# ADDENDUM NO. 3

**January 18, 2024**

# CHESTERTON HIGH SCHOOL STADIUM IMPROVEMENTS Chesterton, IN 46304

**Addendum Three (AD.03)** to the drawings and specifications prepared by Gibraltar Design for **Duneland Chesterton HS Stadium Improvements** for Duneland School Corporation, Chesterton, Indiana.

#### 4. Sheet C-5.1

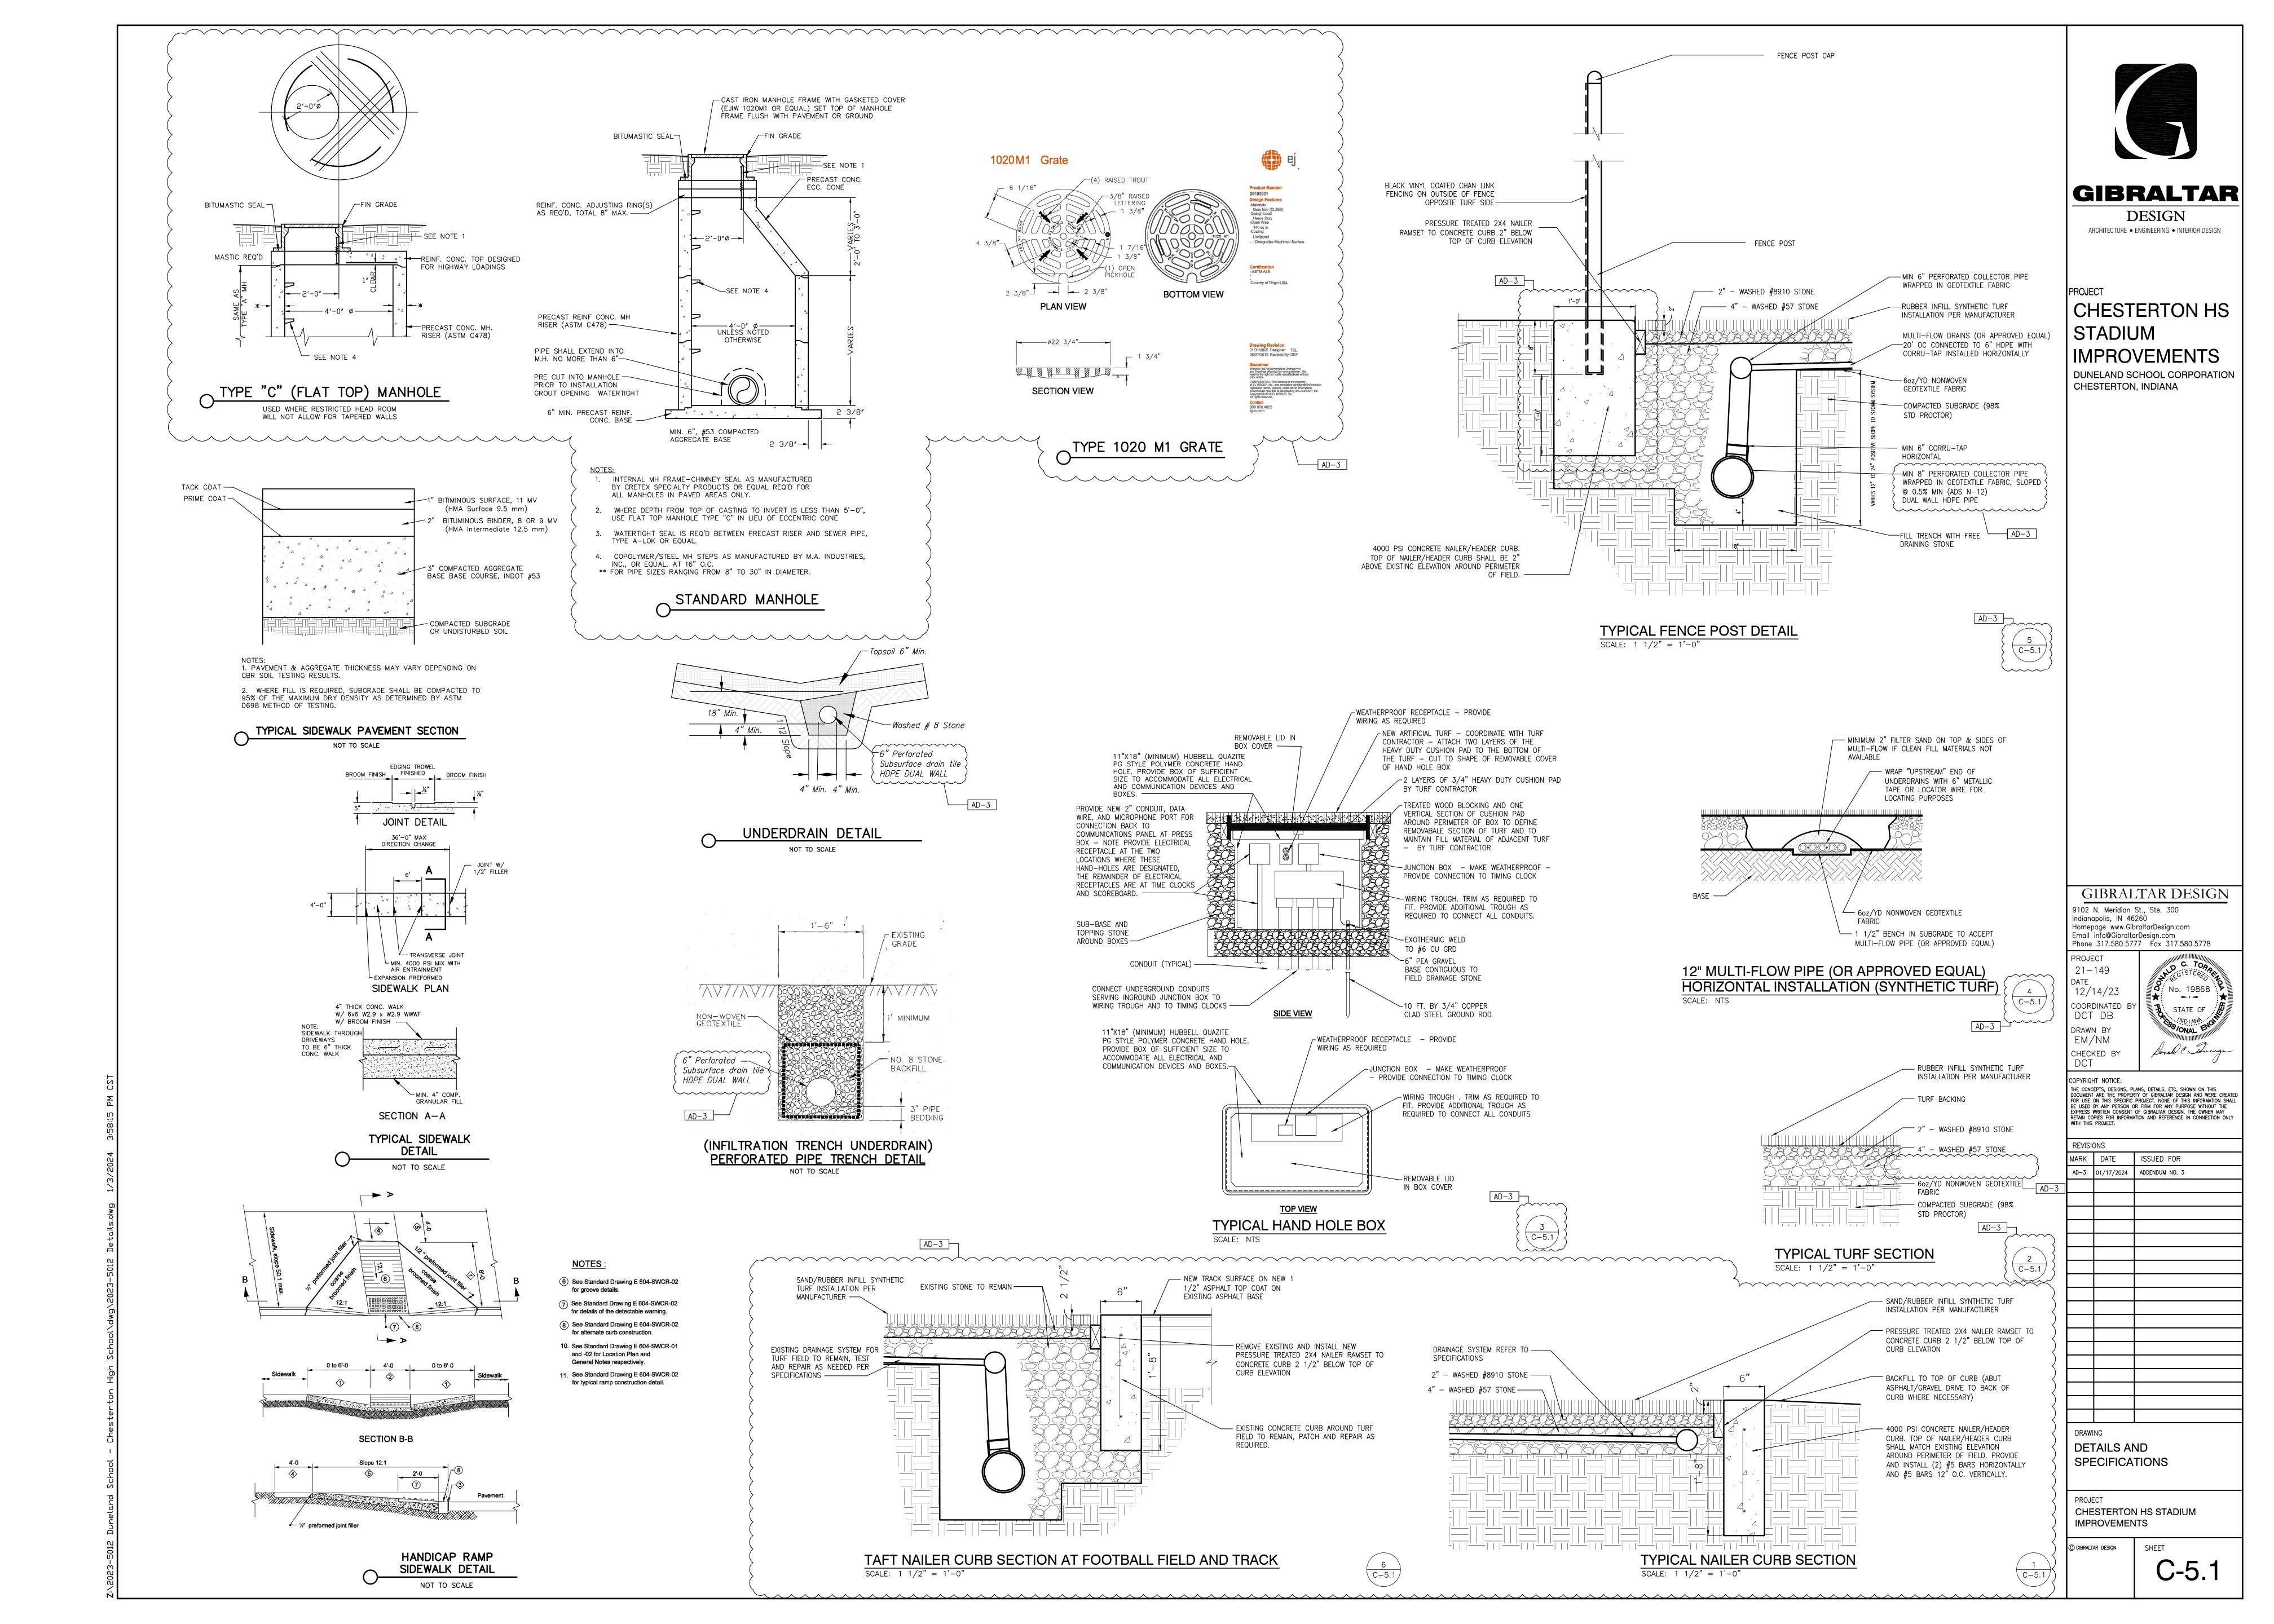
- A. Refer to revised full size drawing included in this Addendum for the following revisions.
  - 1. Neenah Type R-3472 & Catch Basin Type 'A' are removed and replaced with Type "C"(Flat Top) Manholes, Standard Manhole, and Type 1020 M1 Grate details.
  - 2. Updated underdrain detail, using 6" perforated subsurface drain tile HDPE DUAL WALL
  - 3. Updated Taft Nailer Curb Section at Football and Track detail. Corrected label as 6/C-5.1
  - 4. Updated Typical Nailer Curb Section. Corrected label as 1/C-5.1
  - 5. Updated Typical Fence Post Detail. Corrected label as 5/C-5.1
  - 6. 12" Multi-Flow Pipe Horizonal Installation detail, corrected label as 4/C-5.1

- 7. Typical Hand Hole Box, corrected label as 3/C-5.1
- 8. Typical Turf Section, corrected label as 2/C-5.1
- 9. Removed "Wheeler note form Typical Turf Section Detail.

#### 5. Sheet C-5.2

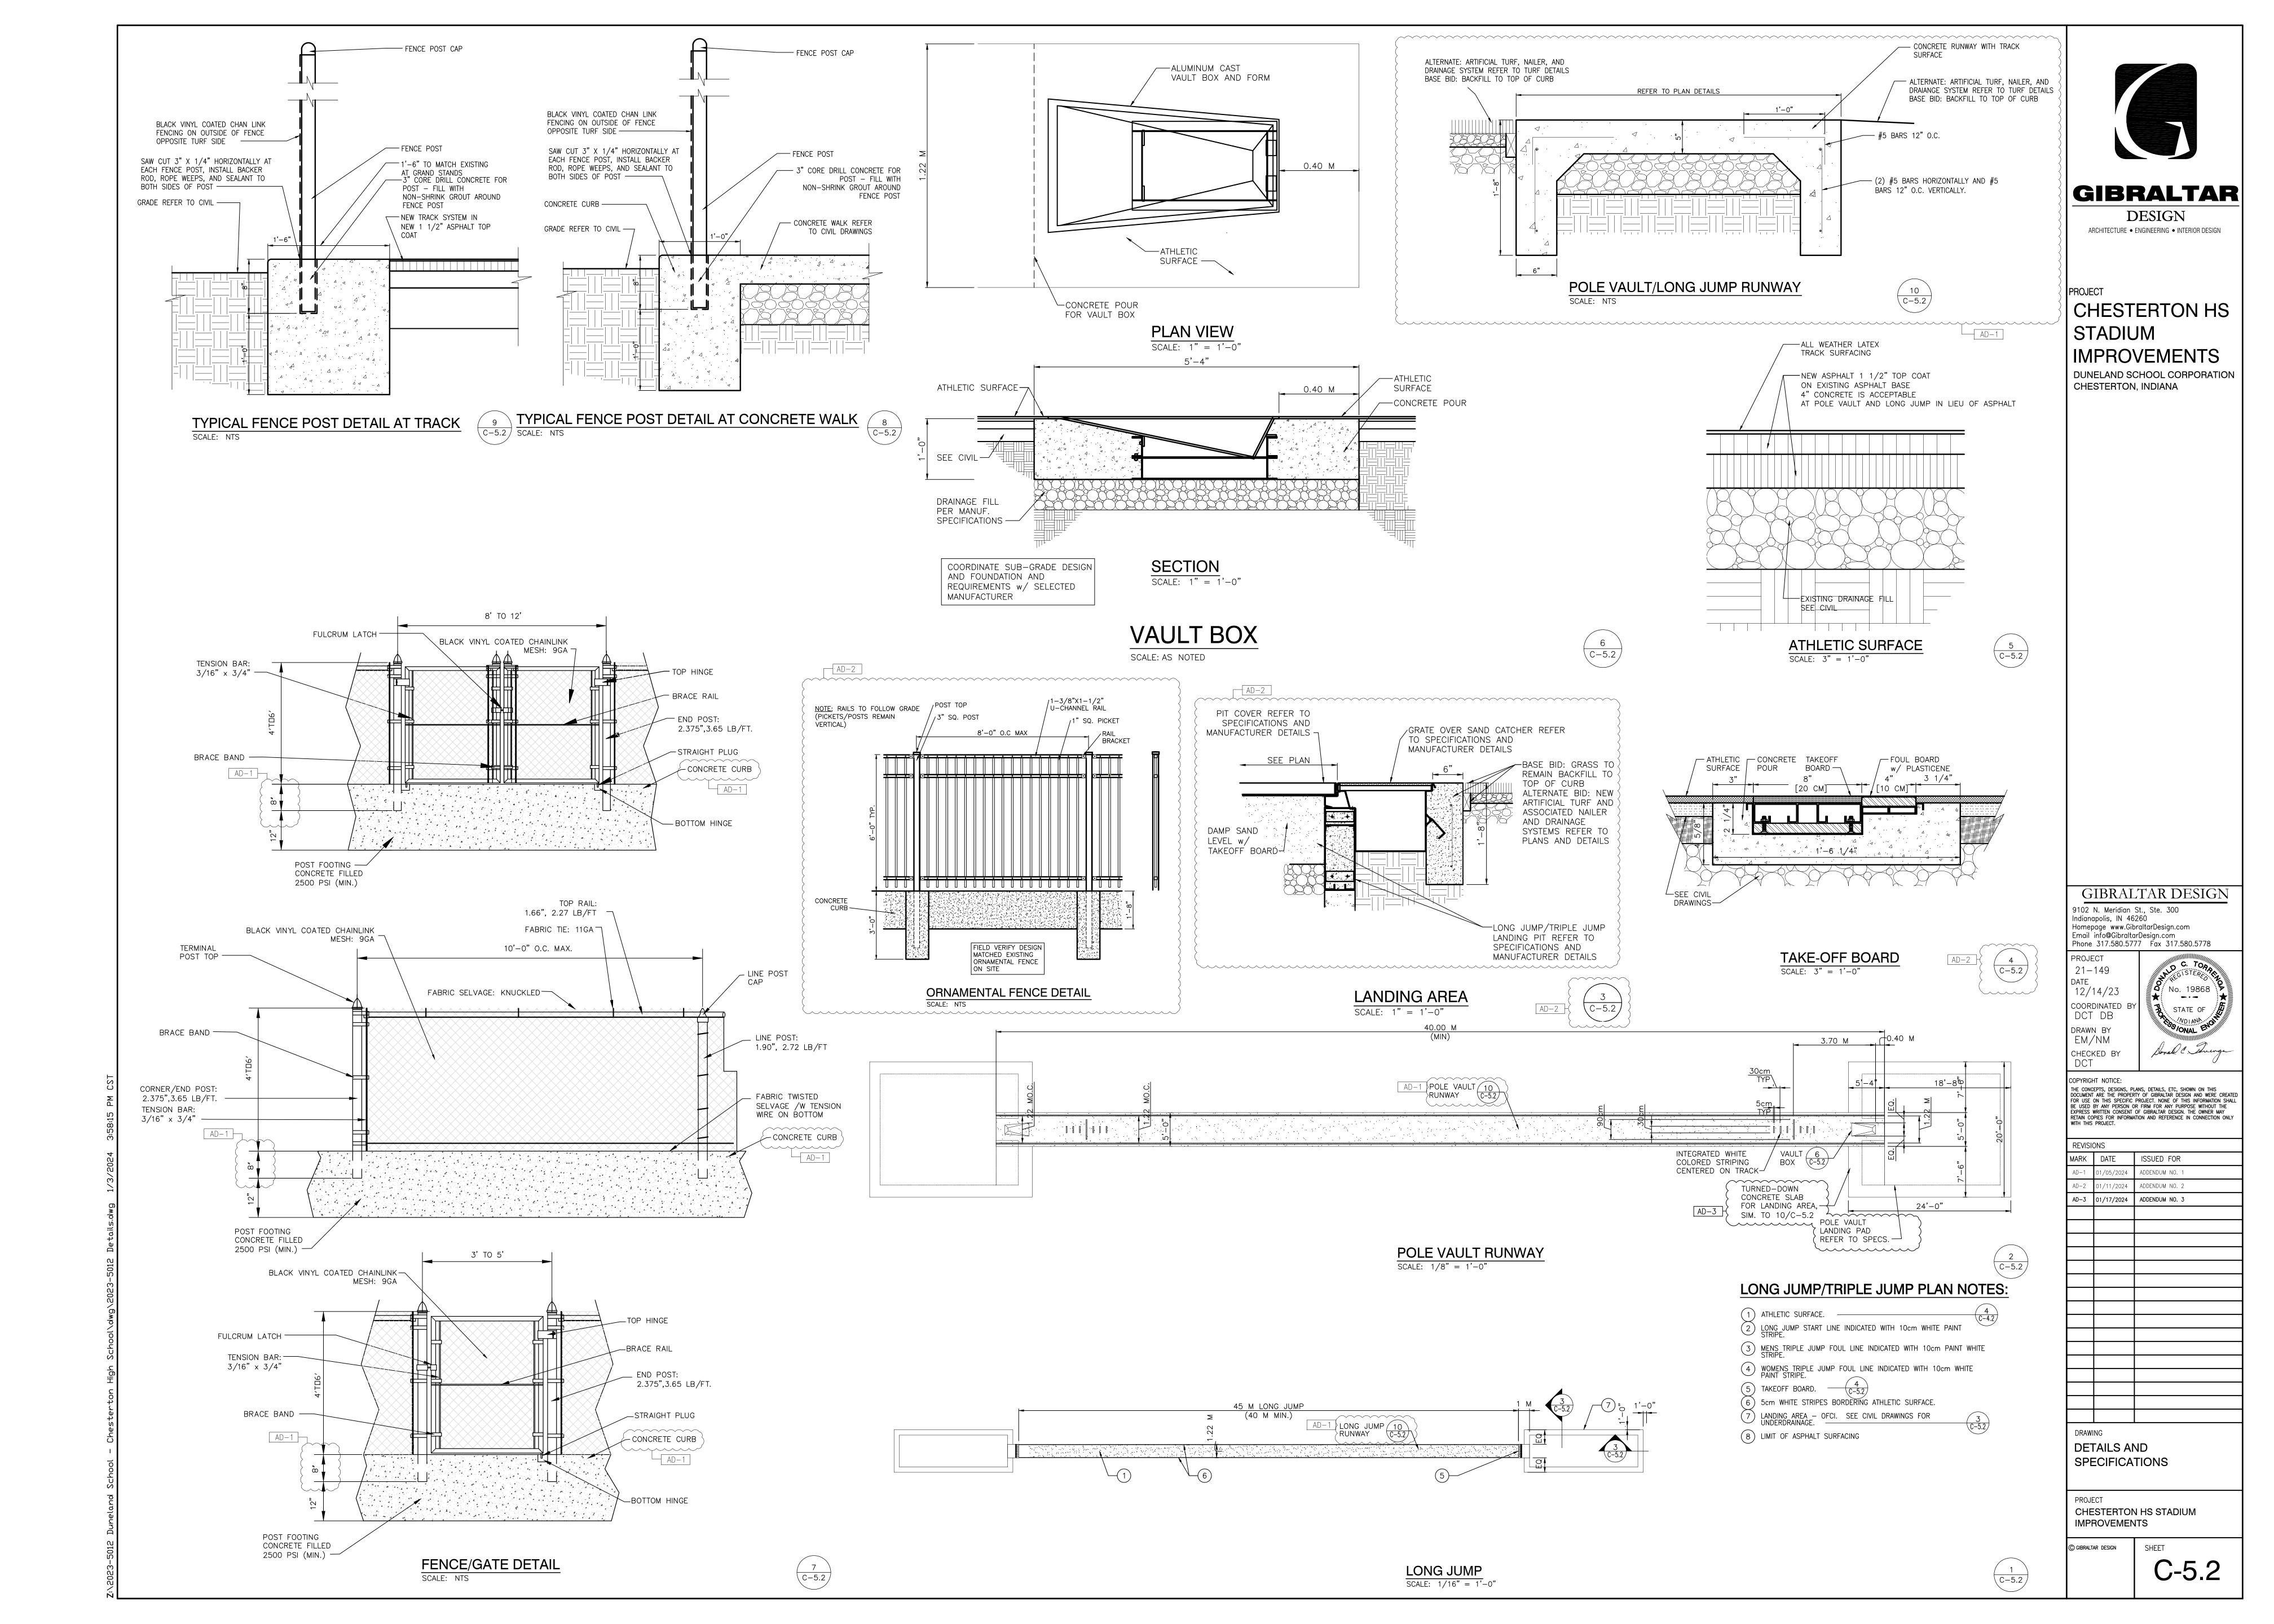
- A. Refer to revised full size drawing included in this Addendum for the following revisions.
  - 1. Updated Pole Vault Runway note detail
